**Subject** ▶ Change on gear housing and discontinuance of tool rest

**For Models** ▶ 9005B, 9006B, 9005BS (Disc Grinder) and PC1100 (Concrete Planer)

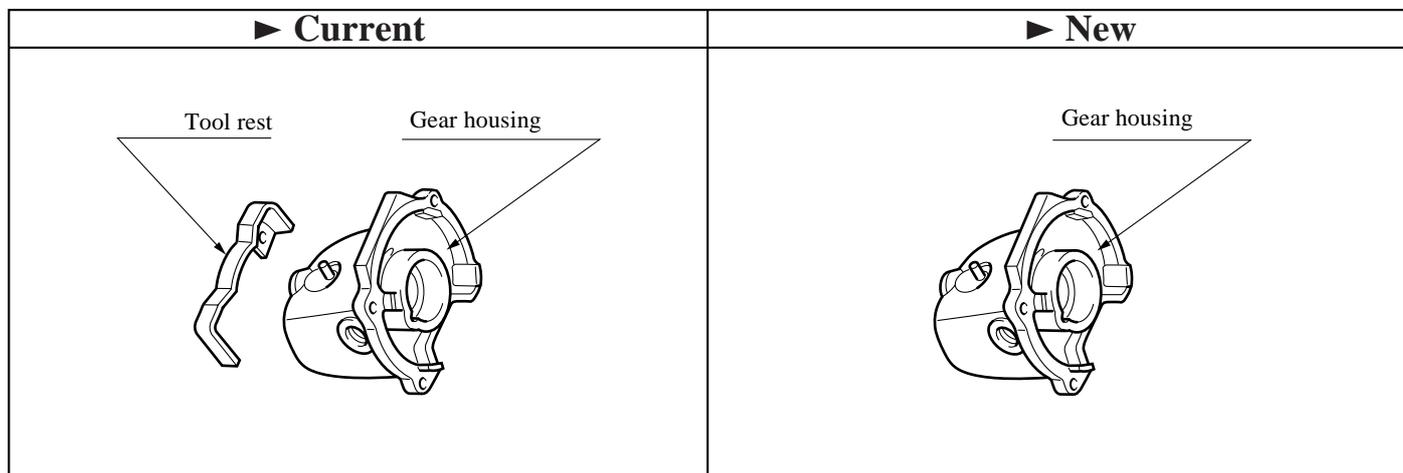
**Description** ▶ 1. The tool rest will be moulded onto the gear housing.

2. The screws which secure the bearing box to the gear housing will be changed as follows.

For Models	Current	New
9005B, 9006B, and 9005BS	Pan head screw M4x14	Tapping screw CT4x16
PC1000	Pan head screw M4x22	Tapping screw CT4x25

Item No.	Current part	Q'ty	I/C	New part	Q'ty	
3	Gear housing 156735-2	1	No	Gear housing 159710-7	1	Interchangeable as a set
2	Tool rest 341680-6	1				
31	Pan head screw M4x14 911121-2	4	Yes	Tapping screw CT4x16 266034-5	4	For 9005B, 9006B and 9005BS
29	Pan head screw M4x22 911141-6	4	Yes	Tapping screw CT4x25 266040-0	4	For PC1100

- The new type gear housing for replacement has tapped holes in it. So either pan head screw or tapping screw can be used to secure the bearing box to the gear housing.
- The tool rest (Pt. No. 341680-6) has been employed in Models 9005B, 9006B and 9005BS but has not not been employed in Model PC1100.
